August 17, 1978

Pursuant to your letter of July 28, 1978 requesting additional environmental monitoring data for the Jackpile-Paguate Mine, the following is in answer to questions 2 and 3 of your letter:

In accordance with your request for further
elaboration on the Jackpile Mine reclamation plan, I am
submitting the attached information.

ENVIRONMENTAL MONITORING
(As per USGS Questionnaire of May 2, 1978)

EXHIBIT B

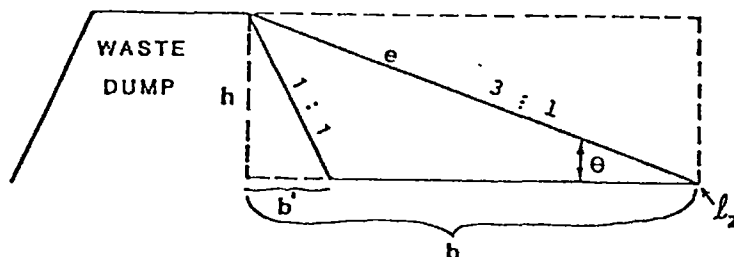
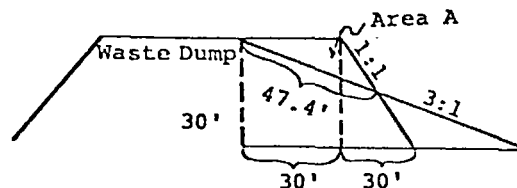
Preliminary estimates (see attached) indicate slope reduction is very costly to implement. Furthermore, alternative procedures which can prove effective for slope stabilization purposes at the mine compare favorably to cost estimates for reducing slope angles (see Cost Summary Table In Appendix D of Reclamation Plan).

PER ACRE COSTS OF STABILIZATION PROCEDURES¹

A. Costs for regrading slopes or waste dumps from 1:1 to 3:1 (Method 1)

$$C = \frac{T/m(d)}{A} = \frac{\frac{495,000}{357}(60)}{21.8} = \underline{\underline{\$3,816}}$$

$$C = \frac{T/m(d)}{A} = \frac{\frac{124899}{357}(60)}{21.8} = \underline{\underline{\$963}}$$
